## DESIGN COMMISSION SPECIAL MEETING AGENDA

#### **Agenda Item #3: DSR2018-003: Alliance Study Session**

Project:	DSR18-003 Alliance Residential Mercer Island
Description:	A Design Commission study session to review a proposed site development concept for a proposed new mixed-use project in the Town Center.
Applicant:	Jeremiah Jolicoeur of Alliance Realty Partners, LLC
Site Addresses:	2885 78 <sup>th</sup> Ave SE; Identified by King County Tax Parcel # 531510-1326
Zoning District:	Town Center -4 (TC-4)
Exhibits:	<ol style="list-style-type: none"><li>1. Plan Set by Ankrom Moisan, dated received on February 7, 2018</li><li>2. Design Review Packet by Alliance, dated received on February 7, 2018</li><li>3. Questions for the Design Commission, dated received on February 21, 2018</li><li>4. Easement, dated received on February 22, 2018</li></ol>

Figure 7 – Preferred Through-Block Pedestrian Connection Locations

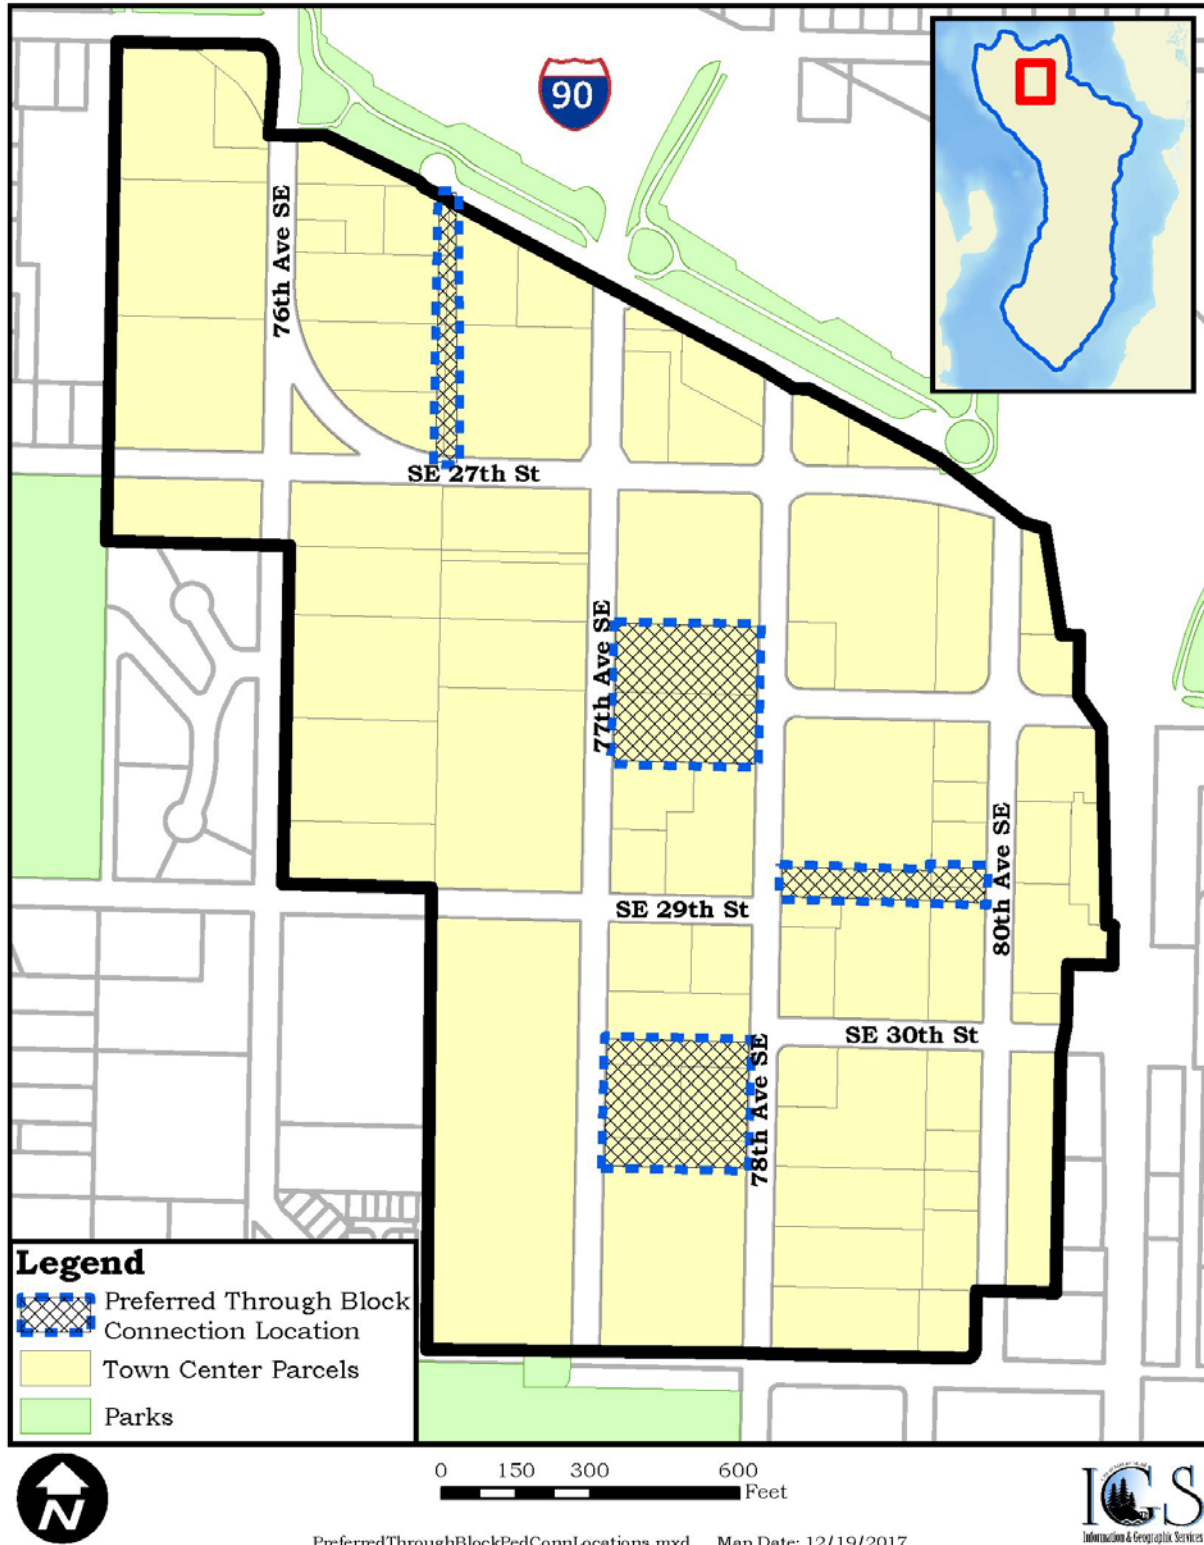
3. **Applicant question:** We do not own property sufficient to create a through block connection and have provided a public open space as our 'major site feature'. Based on current design, is this an approvable approach?

***Staff analysis:*** MICC 19.11.060(B) requires that any new construction located on a property that abuts a preferred through-block connection location shall include a through-block connection subject to design commission determination that such a connection is feasible and achievable. Preferred through block connections are show on this figure:

*The subject property abuts a preferred through-block connection. The preferred through-block connection location is located on the property to the north. The northern edge of the subject property is encumbered by an access easement that provide access to the property to the west (Exhibit 4). This area cannot be encumbered by a through-block connection. If a through-block connection was provided, it would need to be south of the easement, which would locate the connection further away from the preferred location.*

**Figure 2 – Area of Required Retail, Restaurant or Personal Services Use Along Ground Floor Street Frontages**

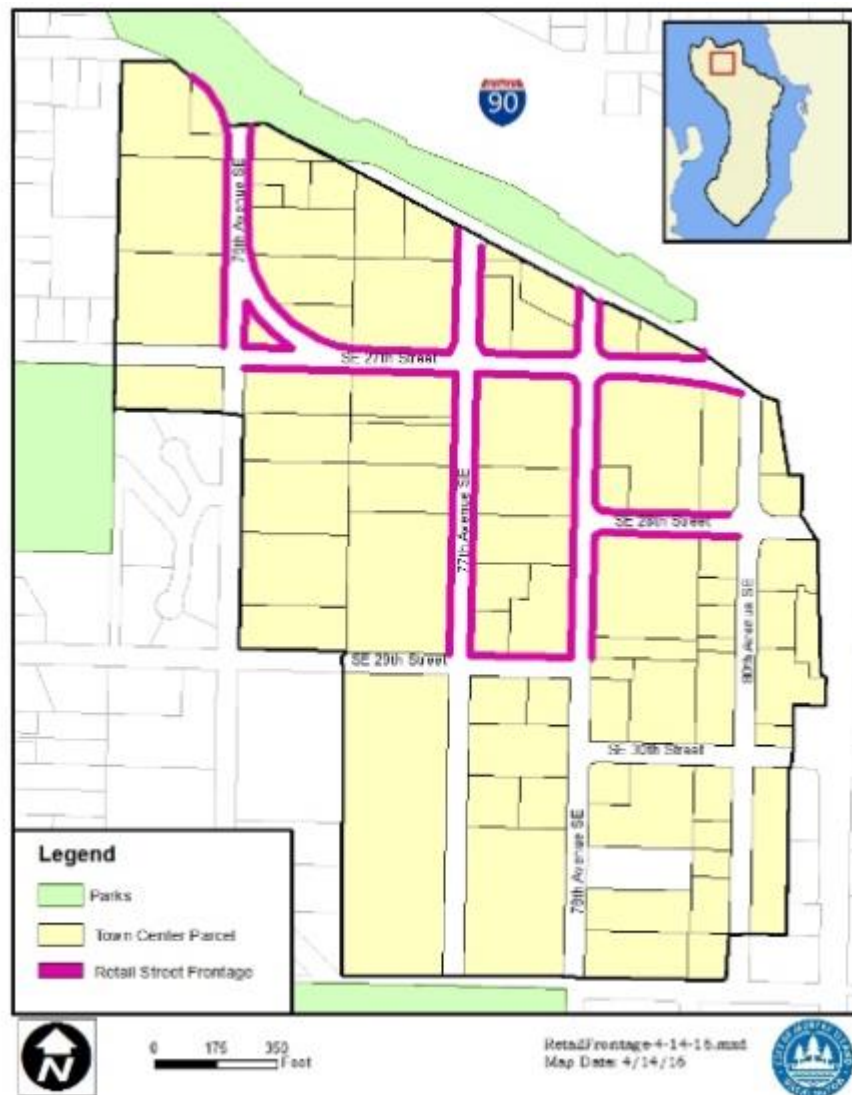
4. **Applicant question:** How does the design commission view amenities we provide to seniors as ground floor uses? Can they count as commercial uses?

***Staff analysis:*** *The code requires a mix of ground floor uses but does not specify if the uses must be open to the public or if they can be amenities of a senior housing complex. A number of code sections refer to provide retail businesses to promote pedestrian activity. It could be interpreted that businesses that are not open to the public would not promote pedestrian activity.*

## BUILDING HEIGHT COMPLIANCE

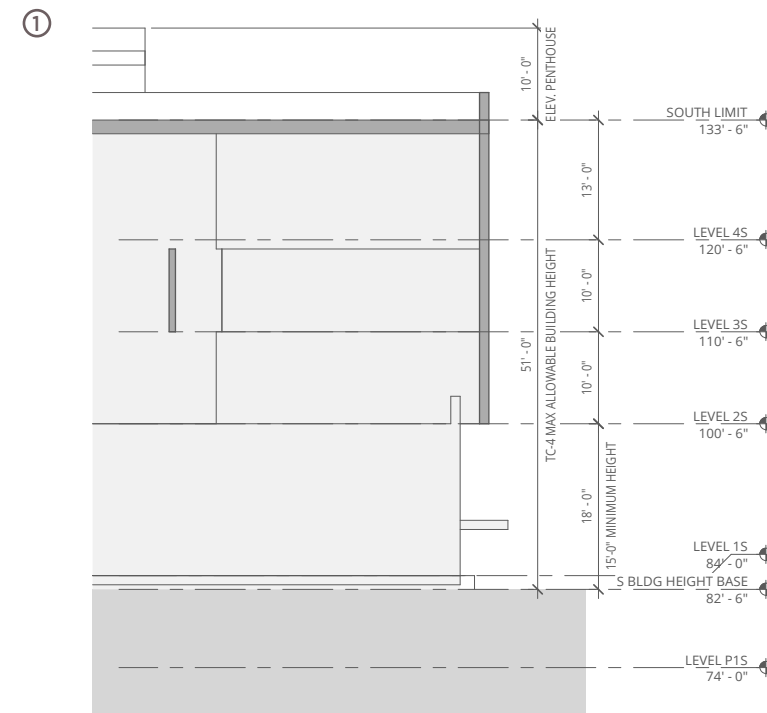
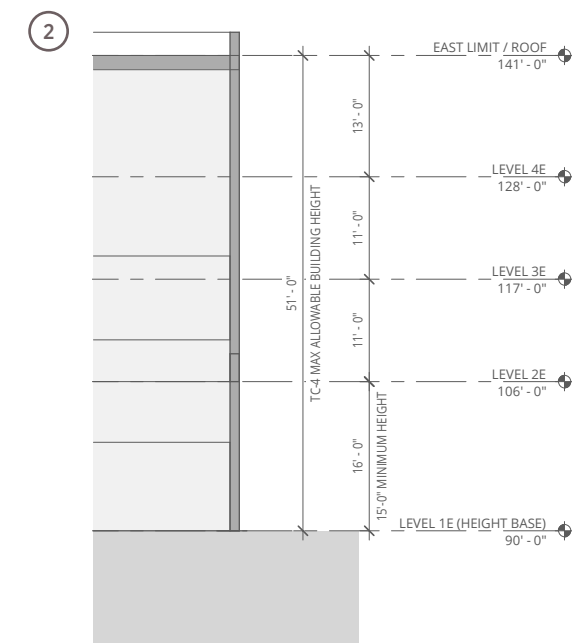
1. **Applicant question:** Our building has two different height limits, calculated from the two different street frontages it is on. This results in two buildings with separate floor levels. Confirm this is the design intent of the code.

**Staff analysis:** *Looking at the elevations on page 9 of Exhibit 2 and the picture depicting the view towards the north on page 17 of Exhibit 2, there is a change in elevation of 8-feet, with the lowest elevation to the west. The applicant has proposed to meet the height limit by constructing two separate buildings. The code provides guidance in MICC 19.11.030(A)(3):*

## THROUGH-BLOCK CONNECTION

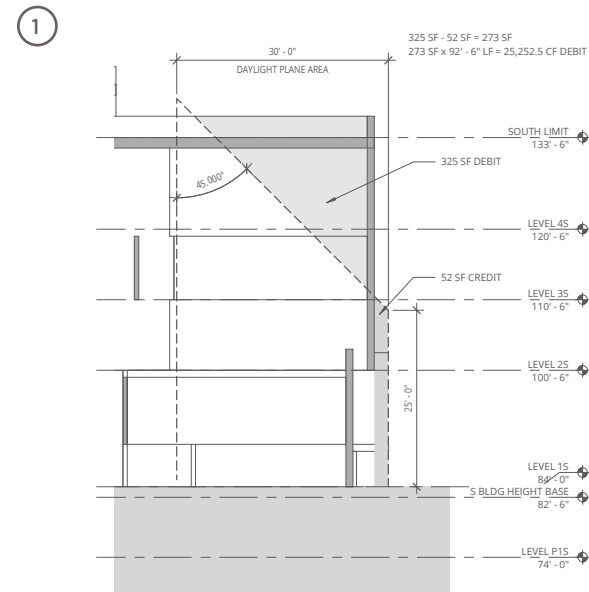
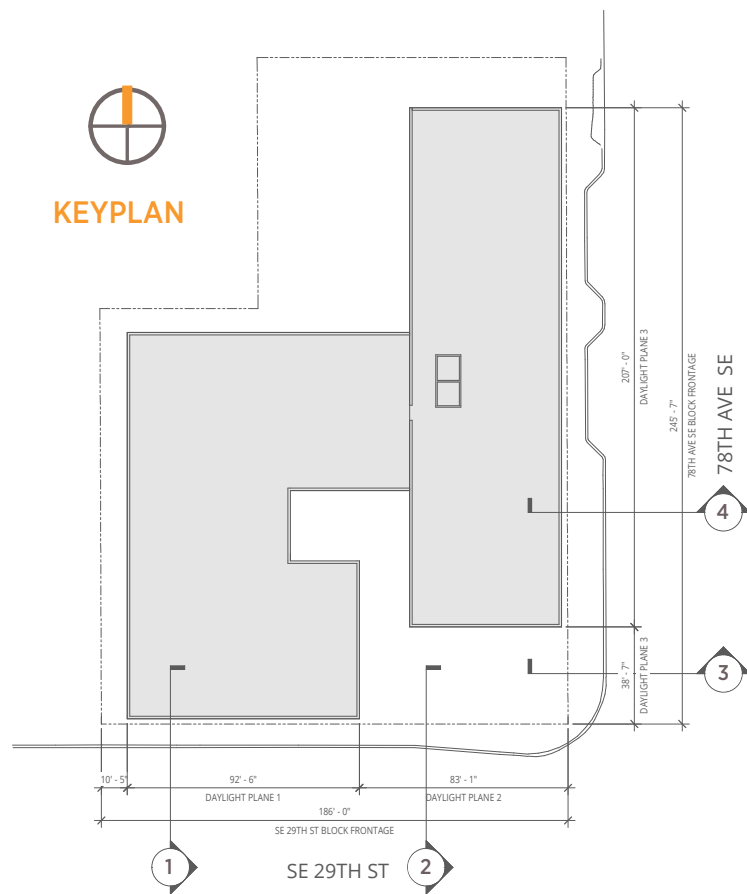
DOES NOT LEND ITSELF WELL TO A THROUGH BLOCK CONNECTION, DUE TO ADJACENT PARCELS WITHIN THE SAME BLOCK. AN EAST-WEST CONNECTION IS NEGATED BY PARCELS 531510-1325 & 531510-1316 ABUT THE EASTERN BORDER OF THE SITE.
